1600 HAMPTON ANNEX – RENOVATION (DLES)

PROJECT NO: H27-I997
USC PROJECT NO: CP00345233
JCS PROJECT NO: 12113

ADDENDUM 01
March 26, 2014

E600

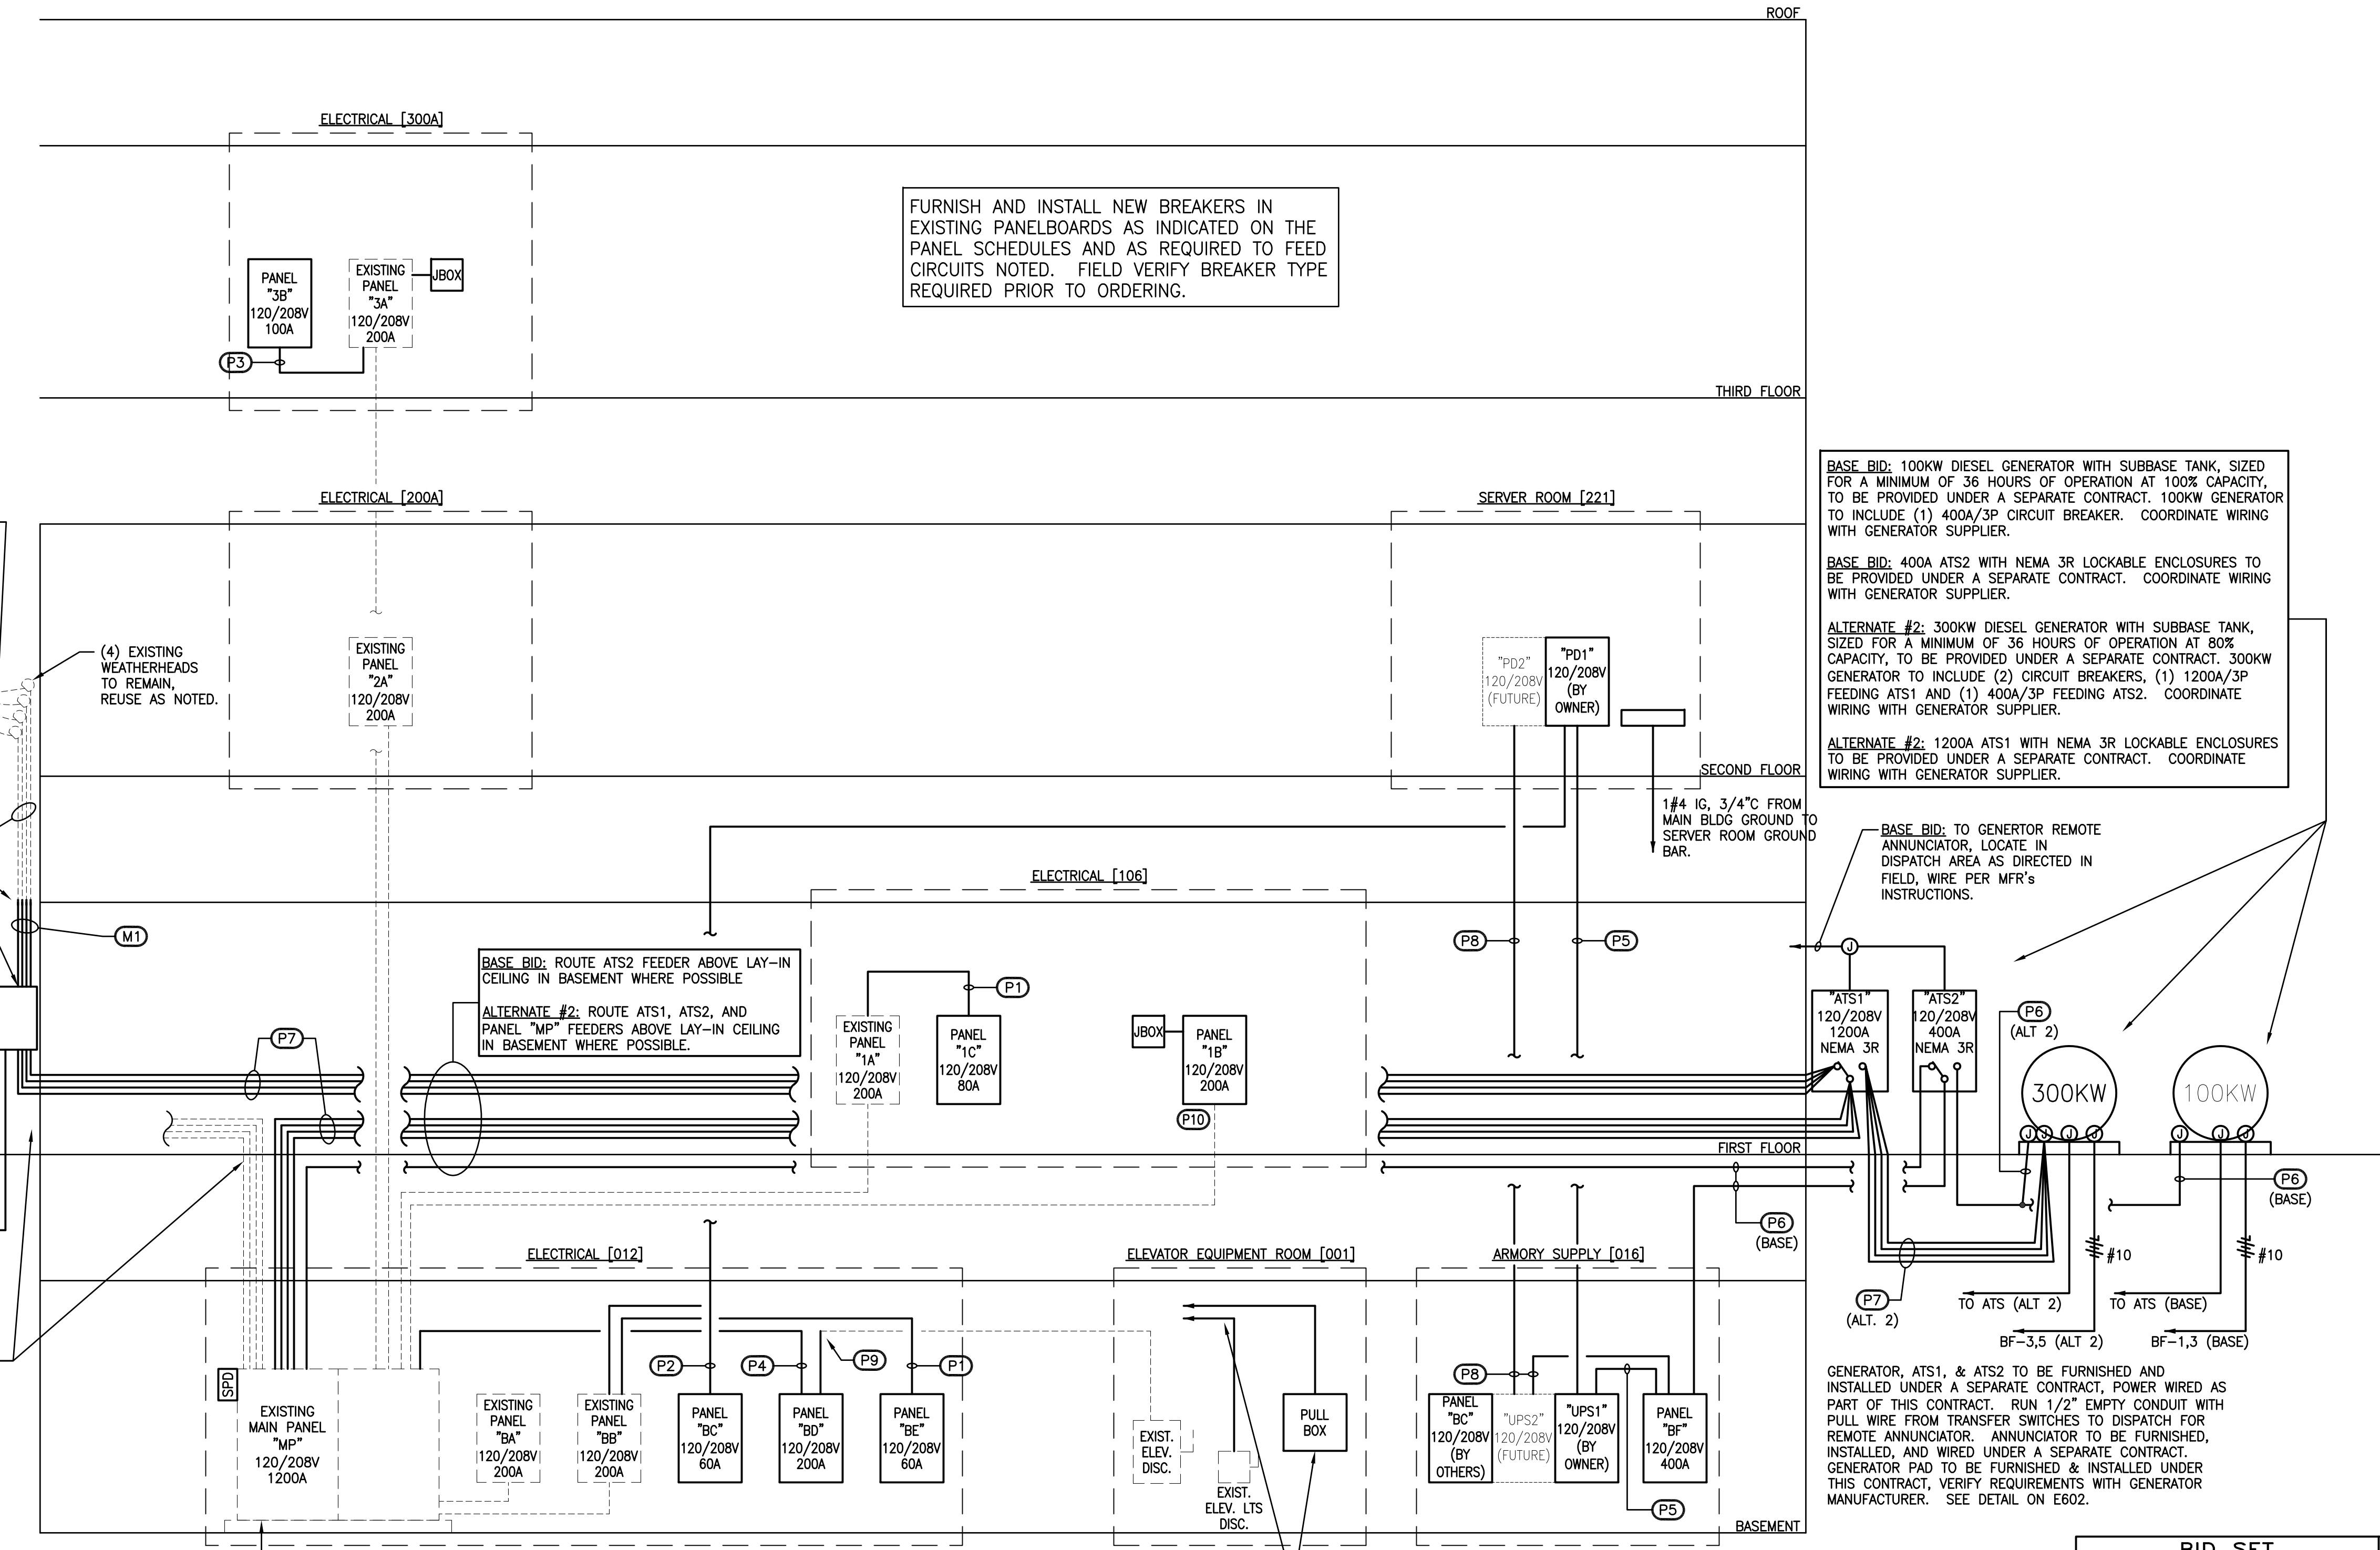
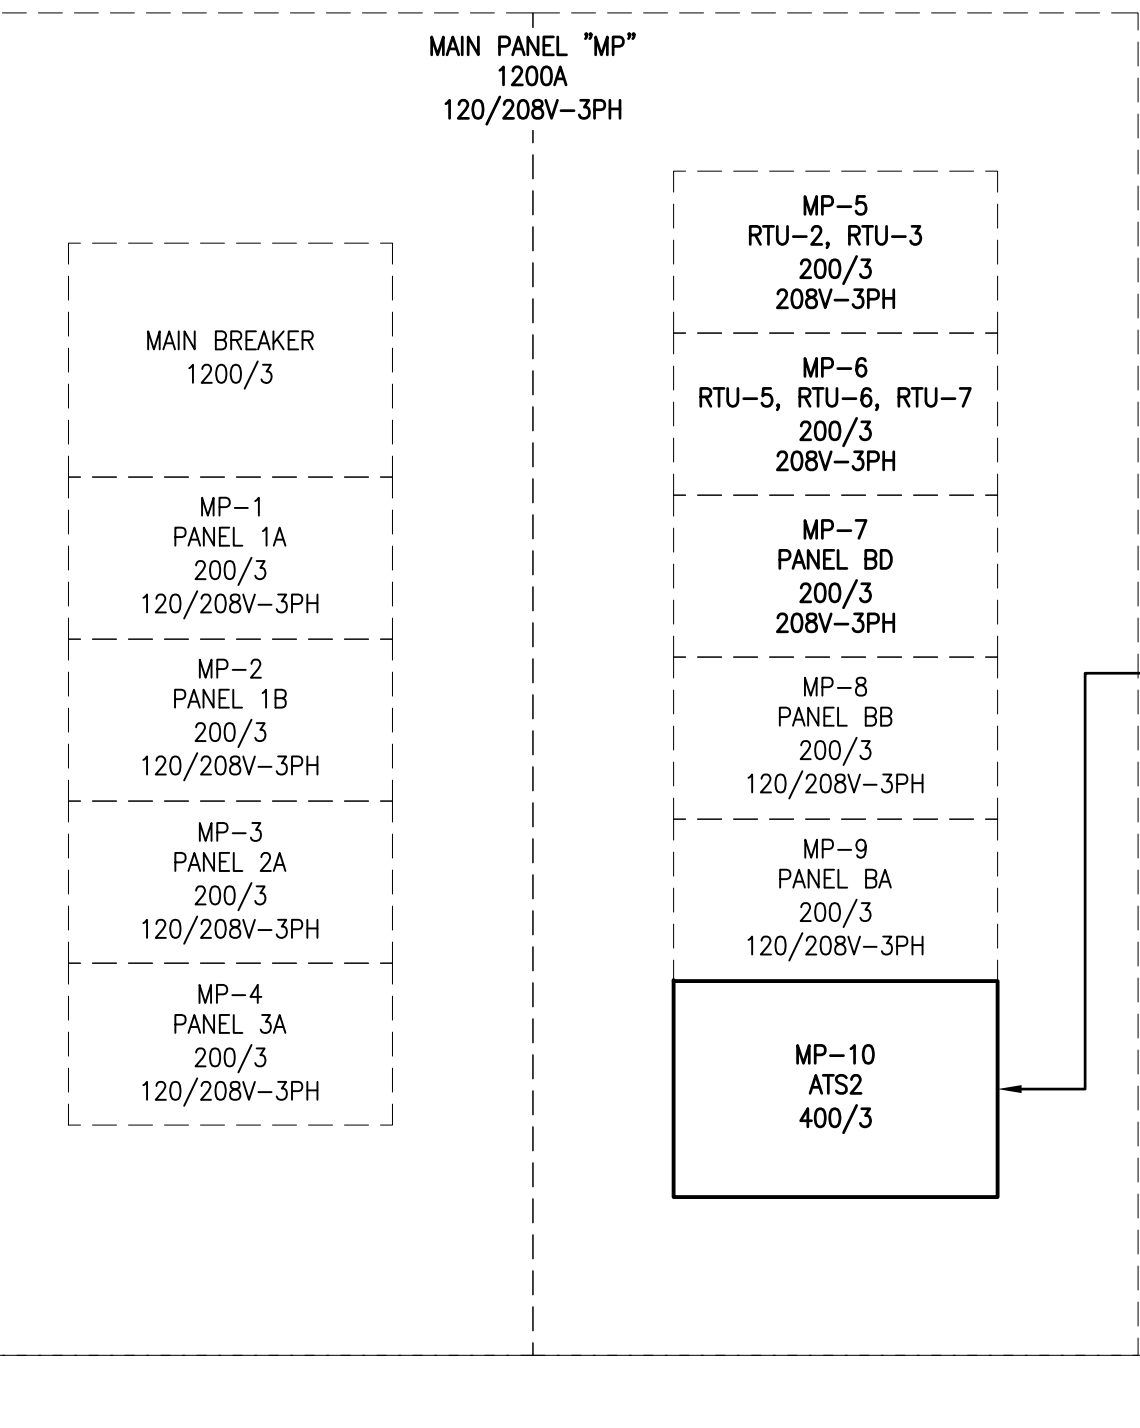
Rework the existing electrical service as noted on Sheets E201, E600, and E601. Work under this alternate includes addition of a 1200A fused main disconnect switch, rerouting of the 1200A main feeder from the 1200A main disconnect switch to ATS1 located at rear of building, and from ATS1 to existing Main Panel MP. ATS1 to be furnished and installed under a separate contract.

ALTERNATE #2: FURNISH AND INSTALL (1) S/E RATED HEAVY-DUTY 1200A FUSIBLE DISCONNECT SWITCH WITH 1200A FUSES, NEMA 3R LOCKABLE ENCLOSURE, LOCK-ON PROVISIONS, SEPARATE GROUND KIT, NEUTRAL ASSEMBLY, RAINPROOF HUBS. MOUNT DISCONNECT ABOVE EXISTING LB CONDULETS.

ALTERNATE #2: COORDINATE REMOVAL/REWORKING OF EXISTING ELECTRICAL SERVICE WITH OWNER AND OTHER TRADES TO MINIMIZE DOWN TIME (NO POWER) TO THE BUILDING. A WEEKEND SHUTDOWN MAY BE REQUIRED FOR THIS WORK.

ALTERNATE #2: EXISTING SERVICE ENTRANCE CONDUCTORS AND ASSOCIATED CONDUIT RUN FROM LB CONDULETS TO 1200A MAIN PANEL MP (4 SETS) TO BE REMOVED. COORDINATE REMOVAL WITH OWNER AND OTHER TRADES TO MINIMIZE DOWN TIME (NO POWER) TO THE BUILDING.
